ADDENDUM NO. 3

PROJECT: Abraham Lincoln High School
Roofing & Waterproofing Project
2161 24th Ave., San Francisco 941116

DATE: May 3, 2016

SFUSD NO.: 11830

WEST ELEVATION - AUDITORIUM (PHASE 2)
 REFERENCE DRAWING - 1/A205, SOUTH AND WEST ELEVATIONS AUDITORIUM BUILDING-C

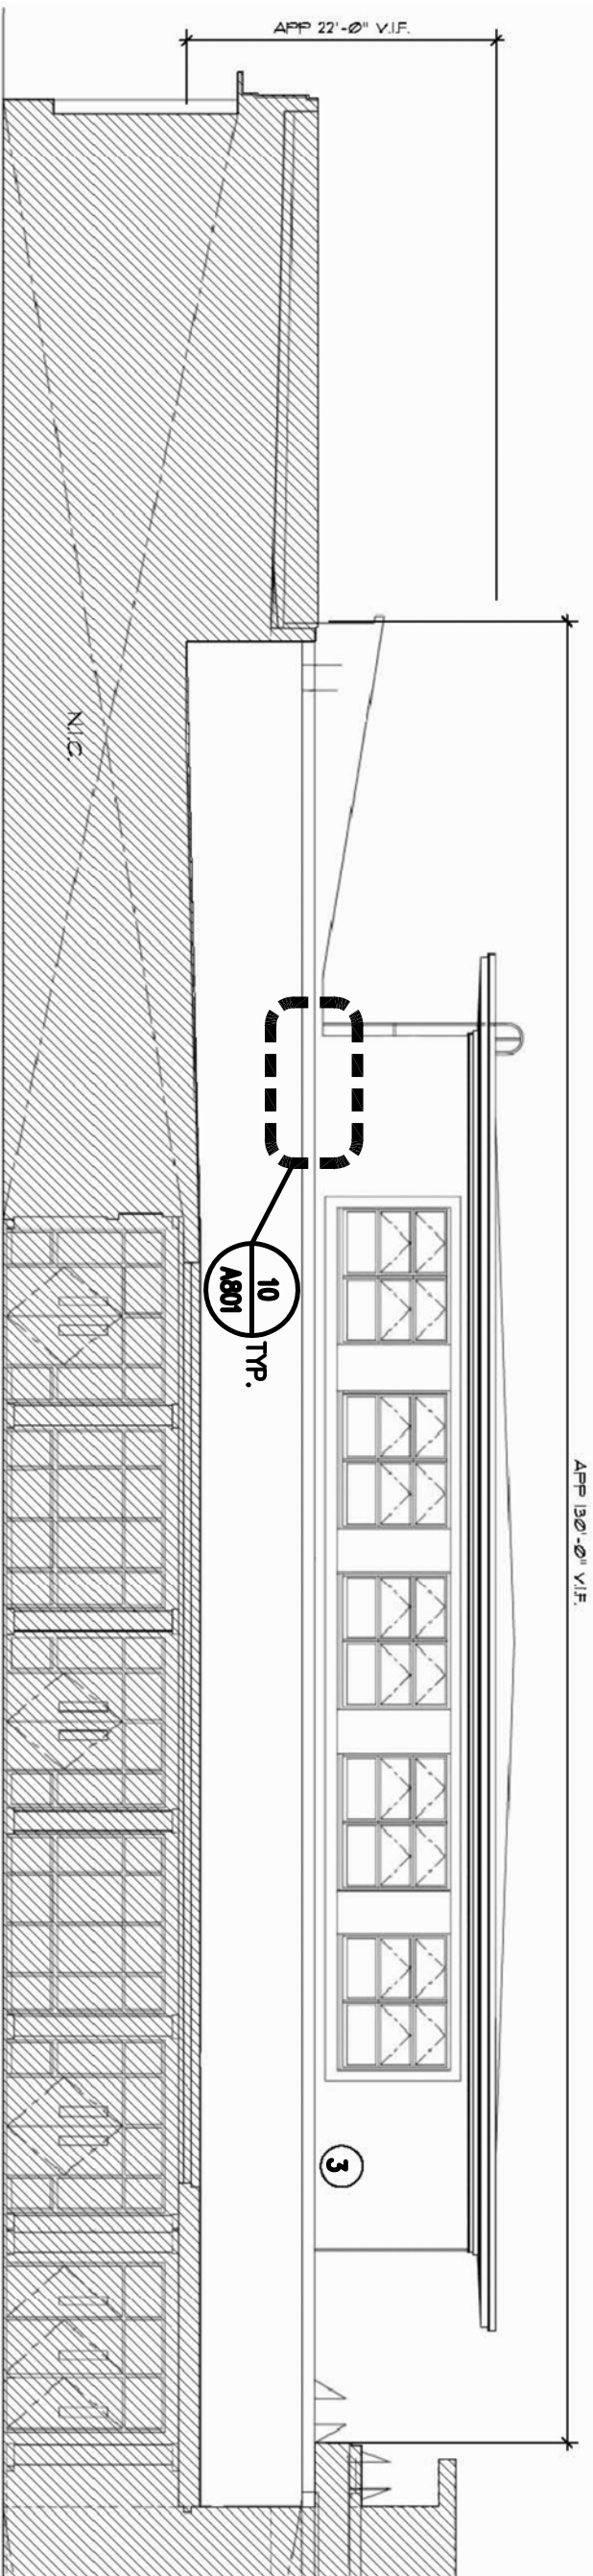
Description: Add new sheet AD3-A1 to address missing information on A205. Refer to Legend and Sheet Notes on A205 for description of notes.
